Official Transcript of Proceedings  
NUCLEAR REGULATORY COMMISSION

Title: Advisory Committee on Reactor Safeguards  
Subcommittee on Fermi Unit 3

Date: Thursday, May 26, 2011

SUBCOMMITTEE ON FERMI UNIT 3

# Chapter 8, Electrical Power: Fermi 3 Transmission System Configuration (Figure 8.2-203)

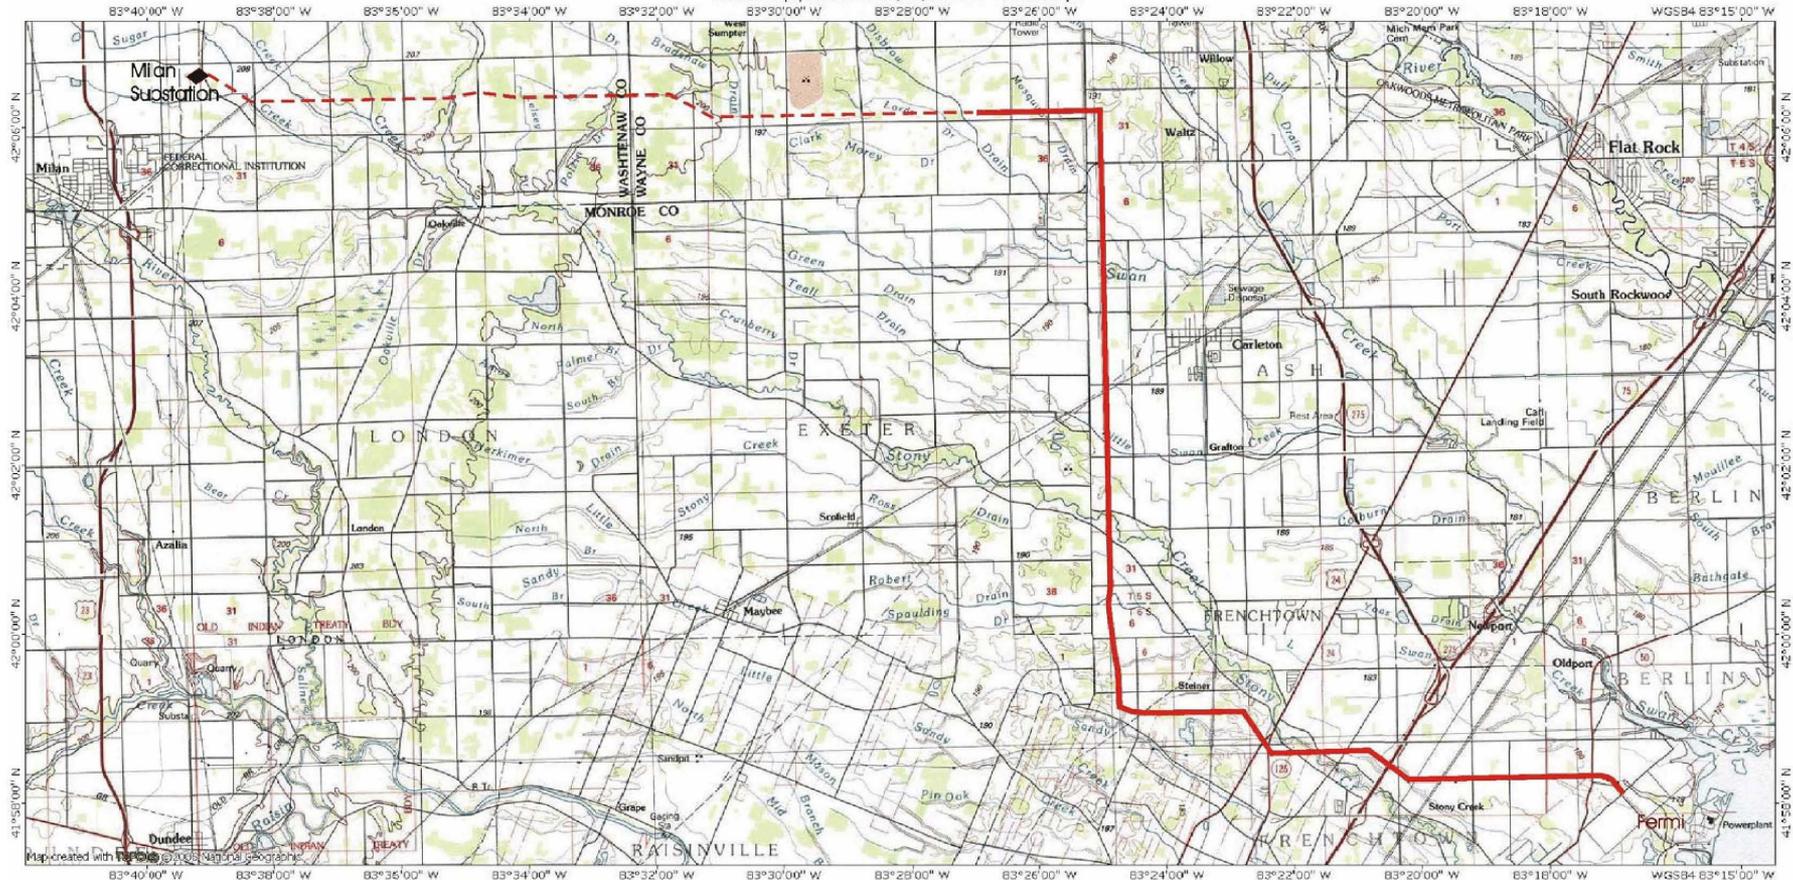
24 Just to give you an orientation for  
25 that, on slide 9 there's a map that shows the Fermi

5 Part of the corridor, the part in the  
6 dark red, is already a developed corridor. There's  
7 already transmission there. The last 11 miles that  
8 is the east/west portion on the top half of the  
9 figure is new transmission.

13 MEMBER STETKAR: Can you go to slide 9  
14 so that we have the graphic in front of us?
